# WINDOW WALL GLAZING BEAD UPDATE

SEPTEMBER 2019  
Technical Bulletin

ABI215

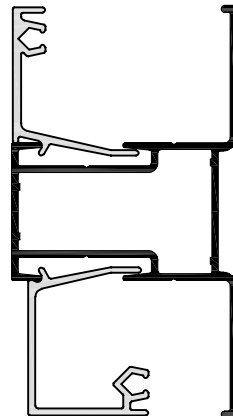
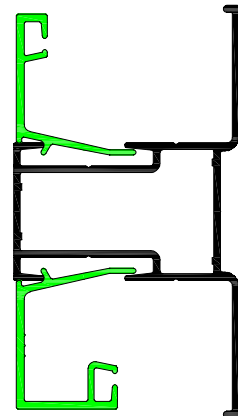
- CURRENT PROFILES WILL BE PHASED OUT NATURALLY AND REPLACED WITH UPDATED PROFILE DESIGNS.

- Improved support for Butterfly gasket allows tight glazing.
- Consistent and flush external bead finish.
- Tested to A4, SANS613:2011
- I.D. lines to distinguish 6 to 14mm beads.

AB262  
5,9m

AB264  
5,9m

AB263  
5,9m

AB261  
5,9m
